DRAINAGE AND TRANSPORTATION INFORMATION SHEET

RE: **HOLIDAY BREEZE SUBDIVISION (F-22/D36)**
Engineers Certification- (additional detail sheets submitted)
Engineers Stamp dated 10/29/1998, Rev. 1/25/1999, 4/21/1999, 6/26/2002
Engineers Certification dated 3/21/2002

REFERENCE: Work Order drawings for Project 622481, HOLIDAY BREEZE SUBDIVISION, located in the northeast quadrant of the intersection of Montgomery Boulevard and Cairo Drive, NE, (east of Juan Tabo Boulevard), Map F22.

RE: **HOLIDAY BREEZE SUBDIVISION (F-22/D36)**
Engineers Certification For Release of Financial Guaranty
Engineers Stamp dated 10/29/1998, Rev. 1/25/1999, Rev. 4/21/1999
Engineers Certification dated 3/21/2002

DRAINAGE PLAN

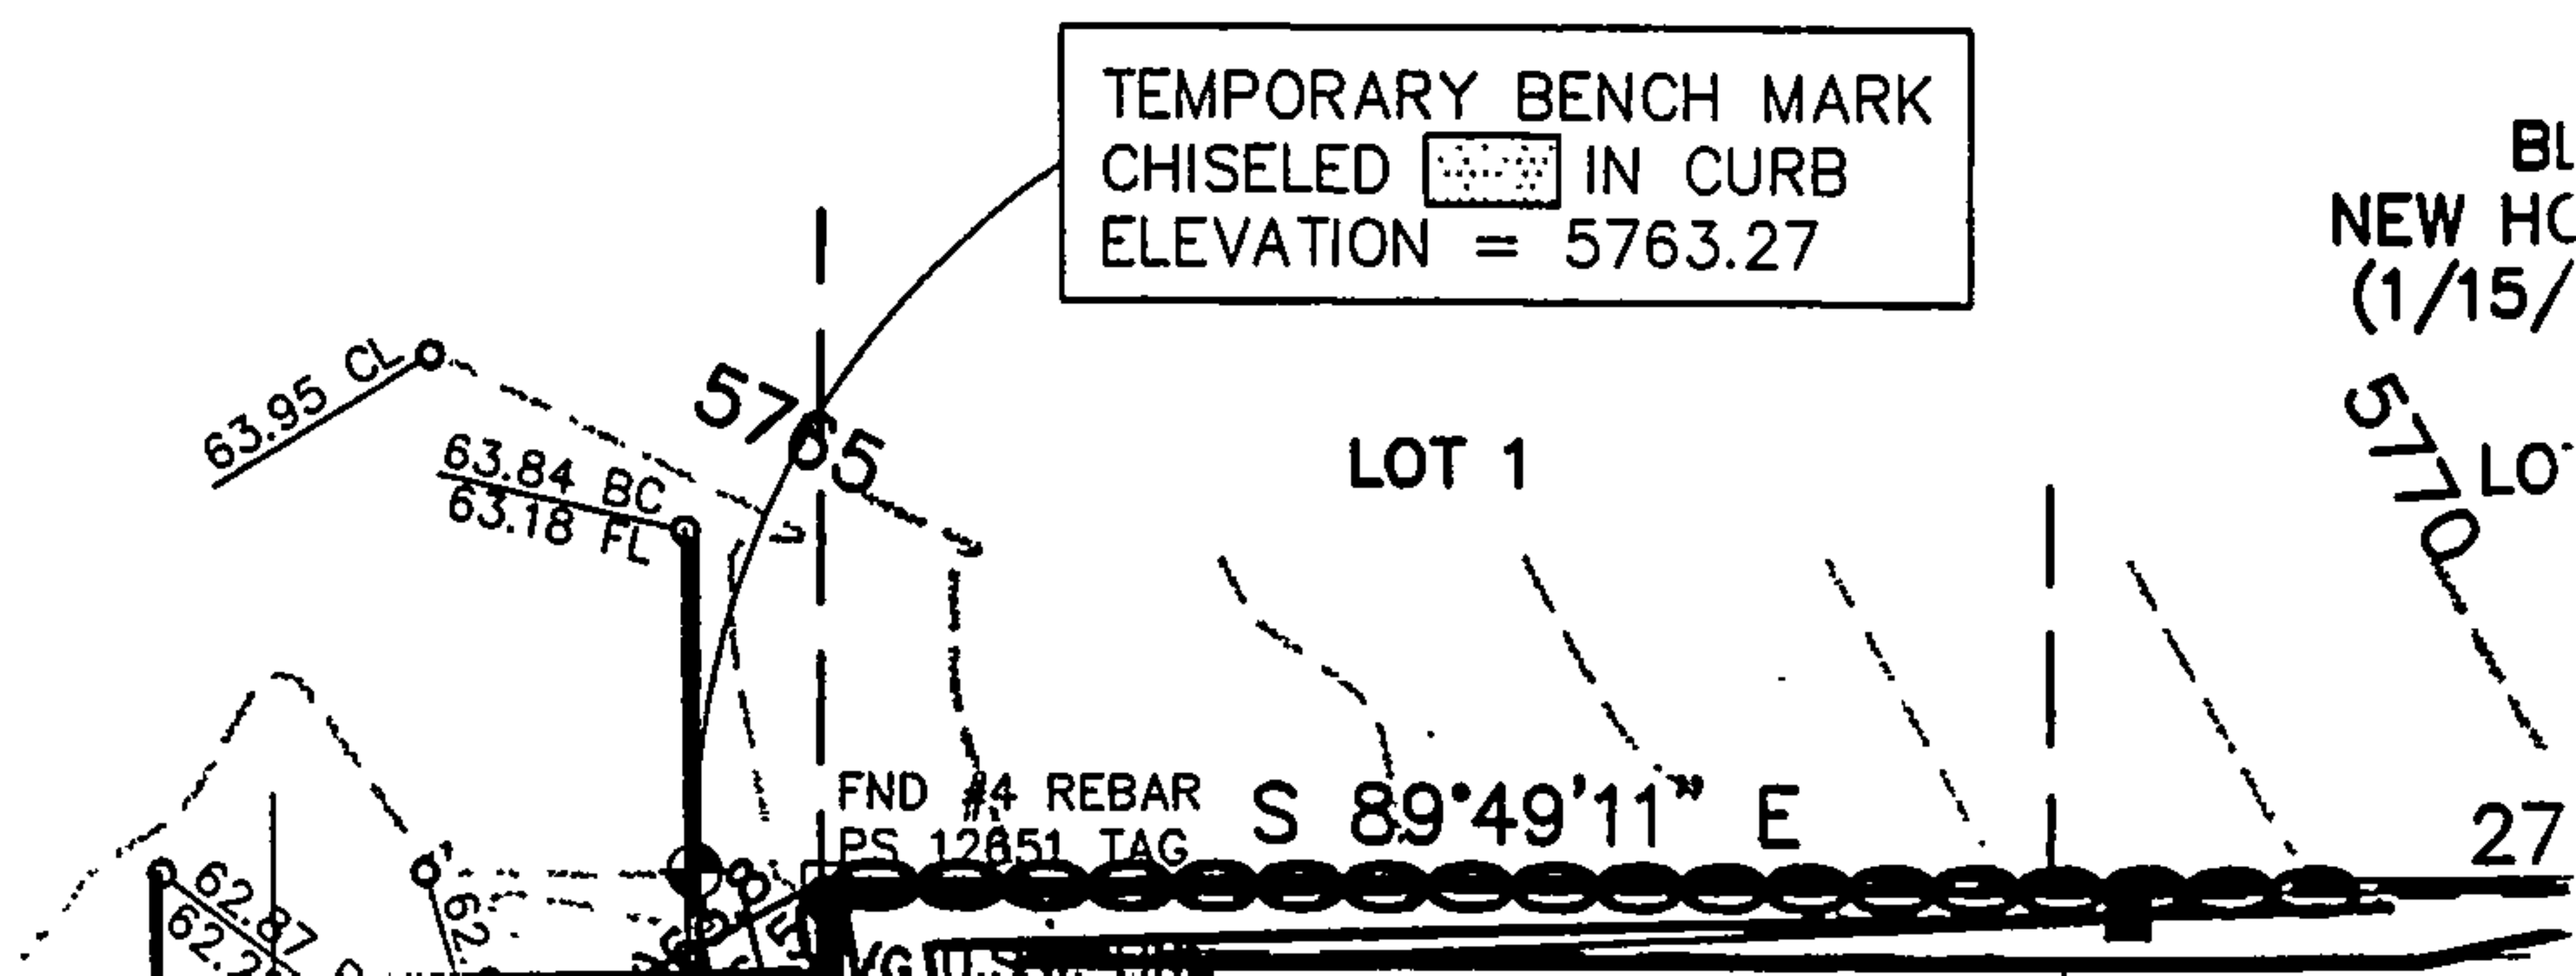
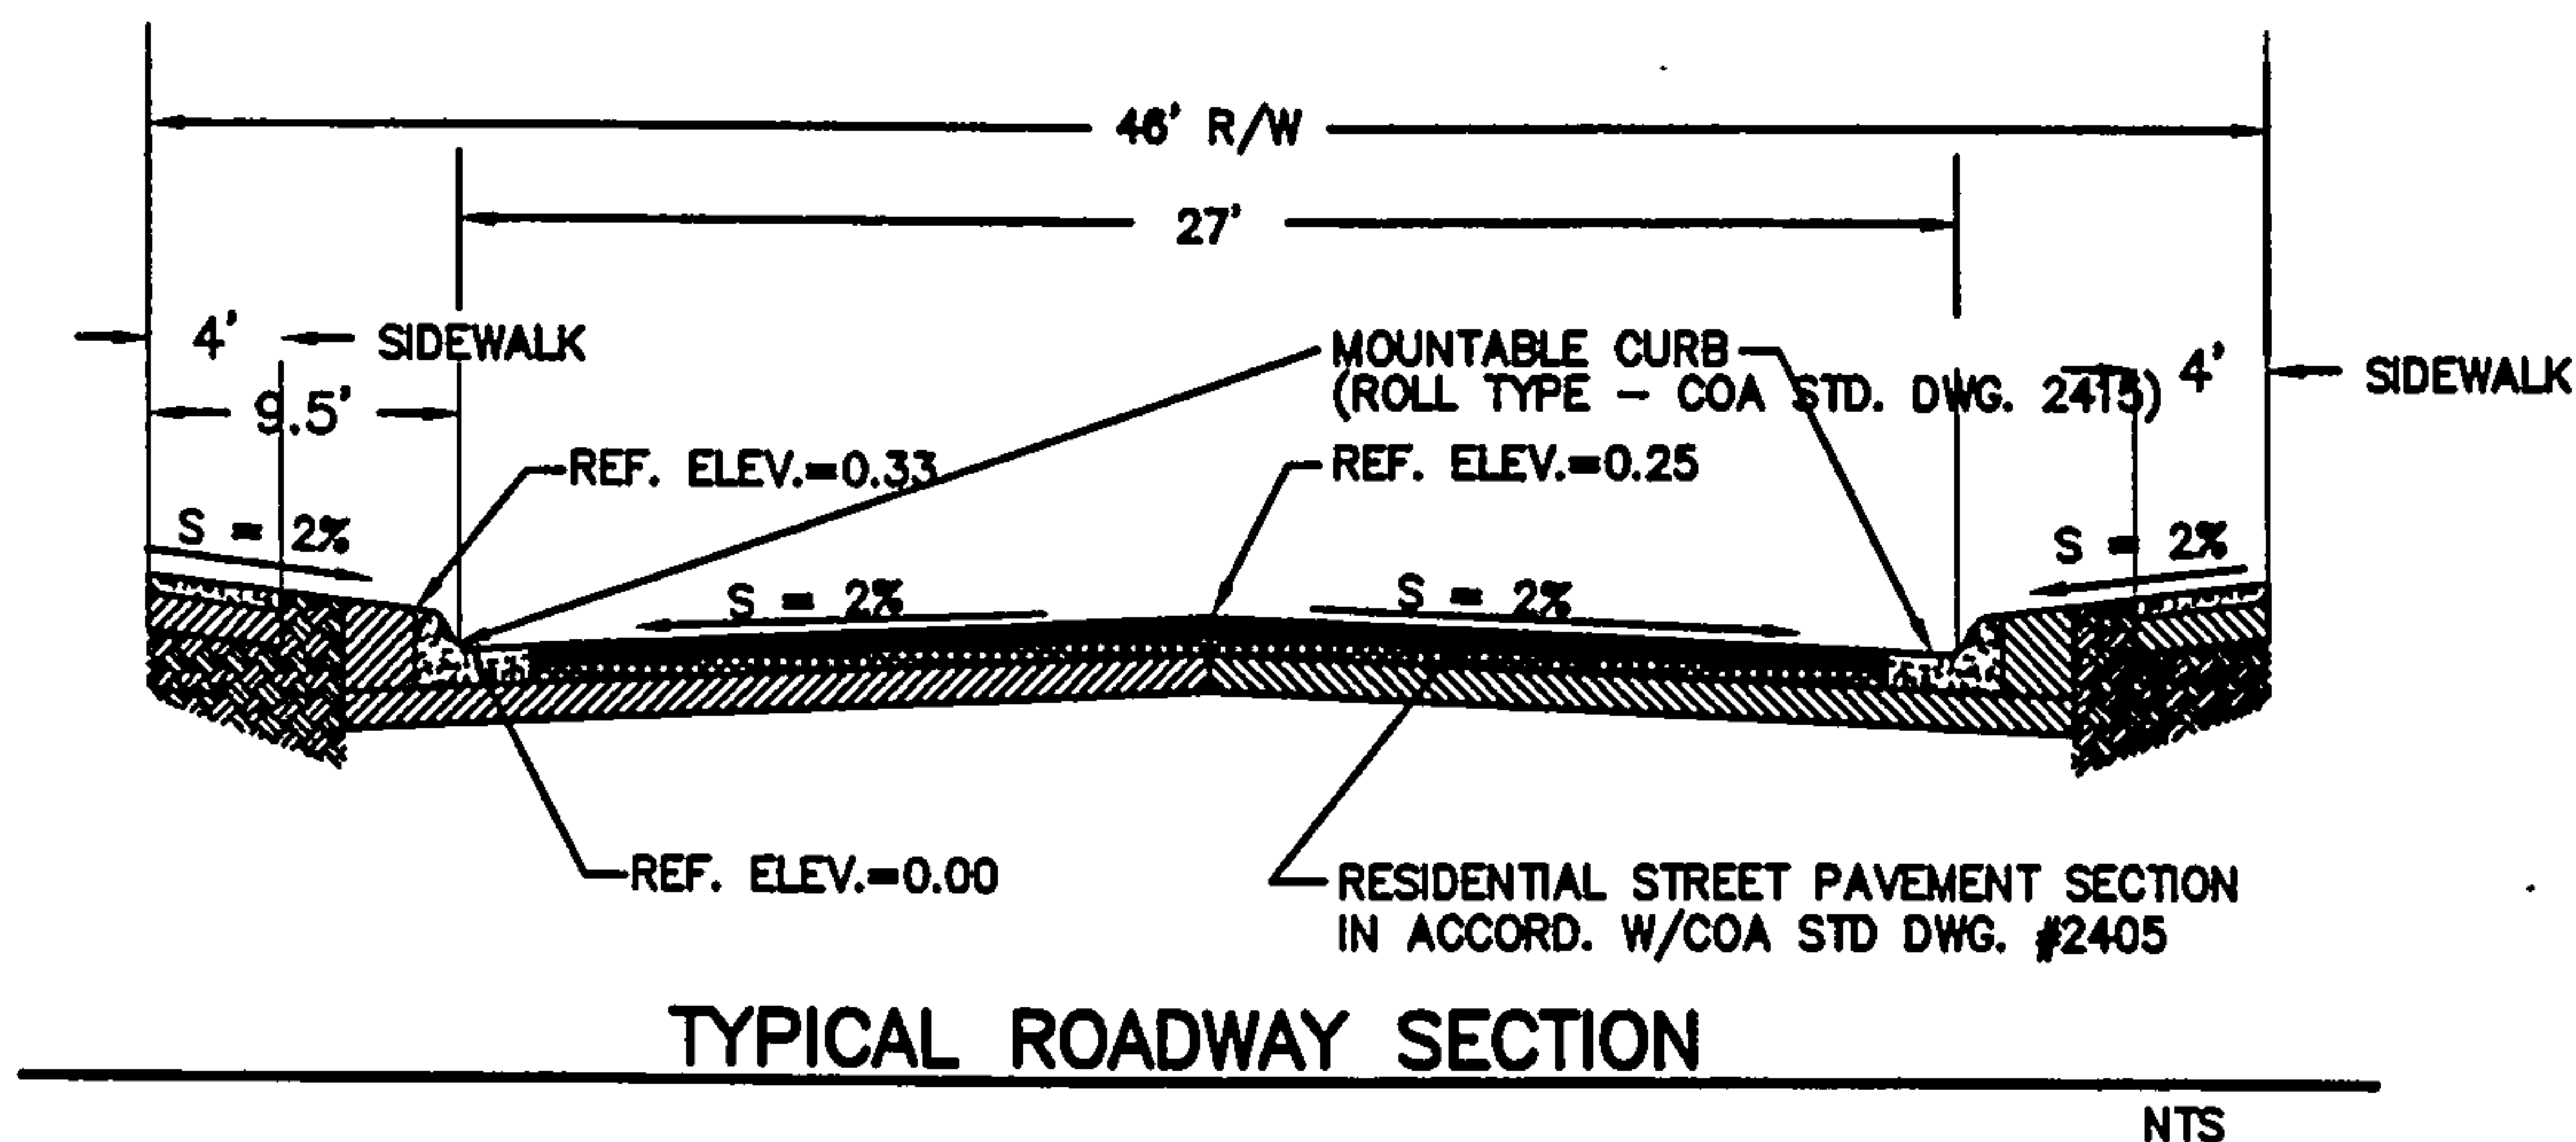
- For the downstream lots, ponding against a garden or retaining wall is not permitted. As we discussed, it appears that the downstream lots within this subdivision all back up to public right-of-way. As a remedy to this situation, please identify on your plan that a weep hole or turned block should be placed in the backyard retaining wall at an elevation just above finished grade (2 or 3 inches). The intent is for nuisance flows to be retained within the yard while excessive storm flow is allowed to spill onto the sidewalk below.
- In regards to the proposed cul-de-sac adjacent to Montgomery Blvd., if you do plan to proceed with a wall opening so that pedestrians can access the site, please do not plan for the drainage spillway to serve also as the walkway. Sidewalk culverts may be the only alternative in this instance.
